In this chapter, the effect of the Proposed Project’s operation on air quality is analyzed and includes a description of the regulatory context, analysis methodology, existing air quality, and the future air quality with the Proposed Project. Air quality effects during construction are analyzed in Chapter 13, “Construction Impacts.” Since the Proposed Project would not increase overall regional traffic volumes, nor the number of diesel locomotives along the Project Corridor, the analysis focuses on changes in traffic patterns around localized intersections (i.e., microscale) that may affect air quality at nearby residential locations and other land uses. As an improvement to a regional transportation system, the Proposed Project contributes to an overall reduction in vehicular emissions throughout the region. In addition, the Proposed Project would not introduce any new permanent stationary sources.

## LIRR Expansion Project Floral Park to Hicksville

Measured LIRR Locomotive Ground-Surface  
Vibration Curves  
**Figure 12-6**

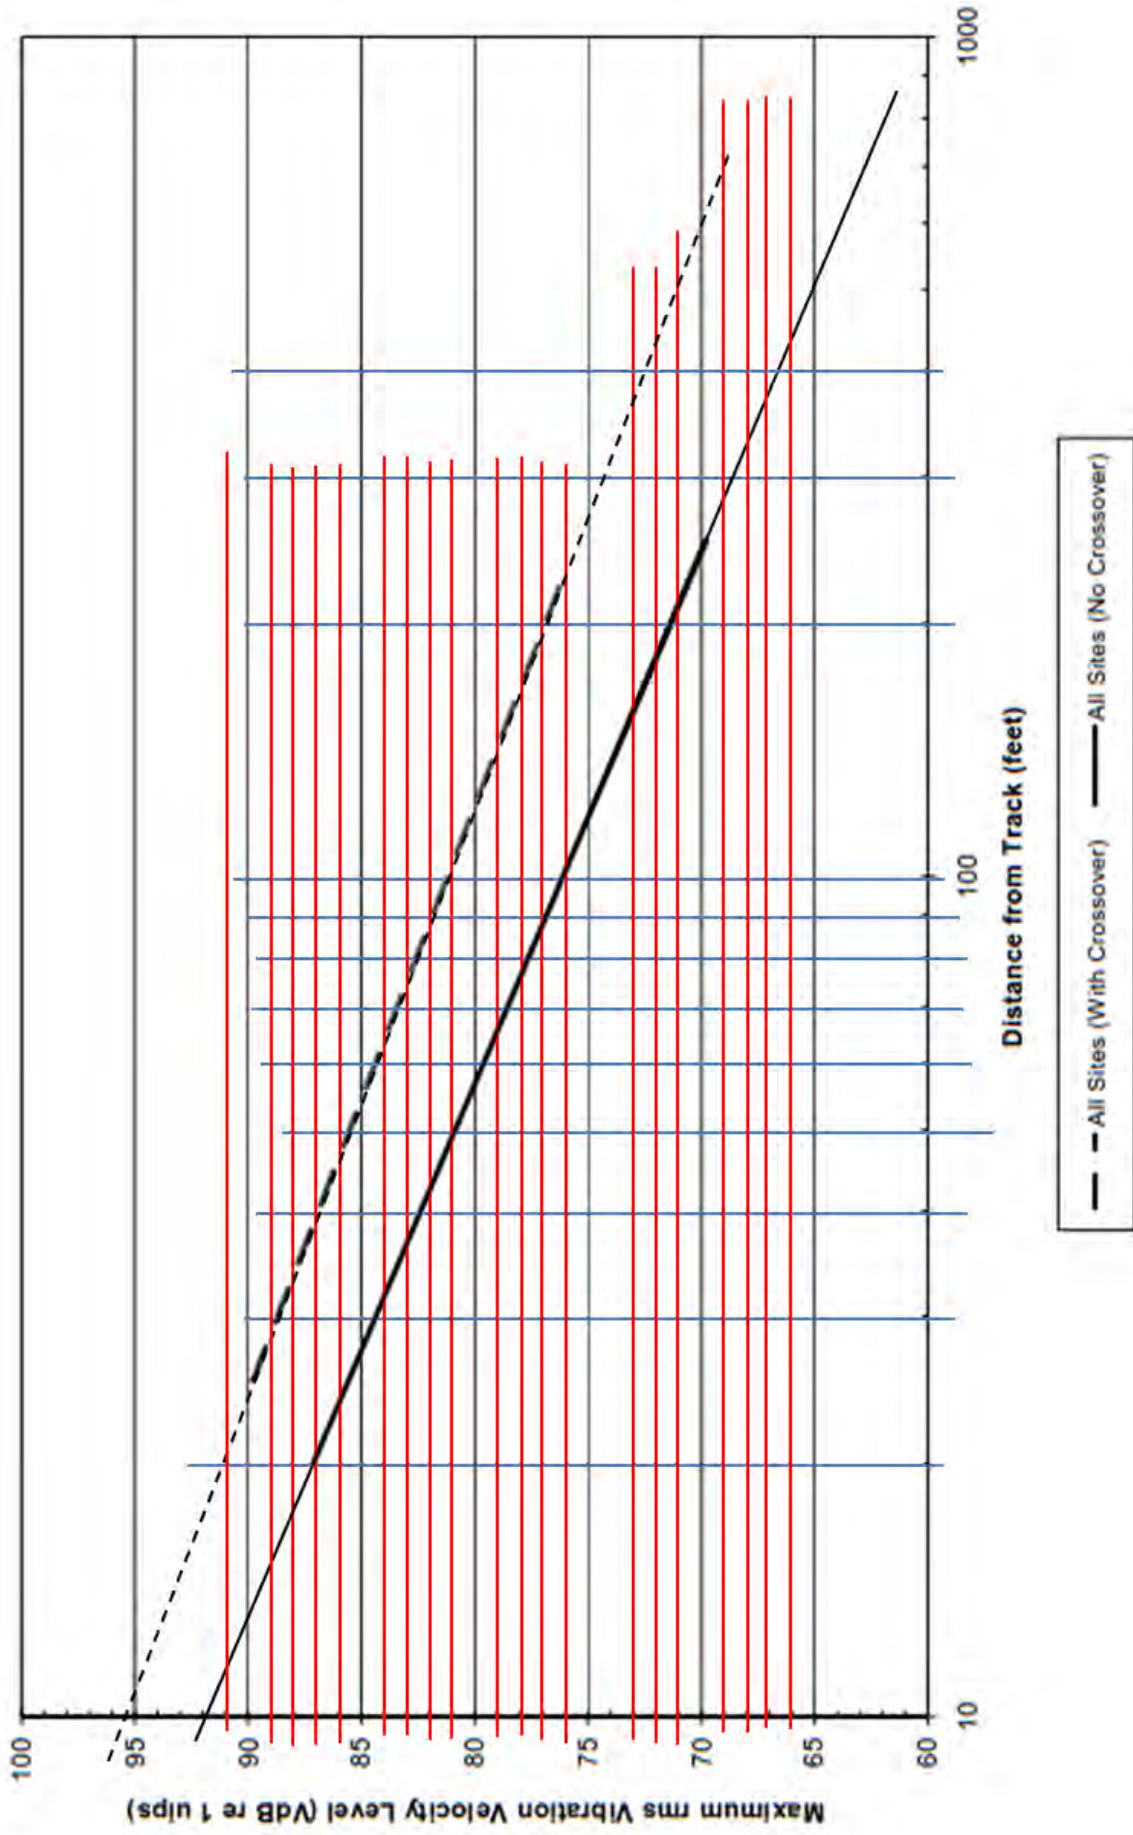
- Incorrect references to Table 12-4, Table 12-5, Table 12-6, Figure 12-6
- Figure 12-6 is not helpful to the average homeowner in determining vibration levels based on distance from track
- Inconsistencies in predicted vibration levels between the text and accompanying tables
- Non-committal language regarding vibration-reducing mitigation measures

**Response 12-12:** The inconsistencies in Tables 12-4 through 12-6 have been corrected in the EIS. Figure 12-6 uses a logarithmic scale for the distance from track measures along the horizontal axis. Thus, from 10 feet to 100 feet from the track, each vertical line intersecting with the horizontal access represents 10-foot increments. From 100 feet to 1,000 feet from the railroad track, each vertical line intersecting with the horizontal access represents 100-foot increments. Vibration levels for track sections with and without crossovers (switches) are measured on the vertical axis where the two diagonal lines cross the vertical lines representing distance from track. Table 12-6 shows the reduction in vibration levels due to the Proposed Project at 12 representative locations. These reductions are based on vibration control measures incorporated into the Proposed Project as well as acceleration of the LIRR's tie-replacement program on Main Line 1 and Main Line 2. The railroad is committed to these measures which will reduce vibration levels as compared to the current condition.
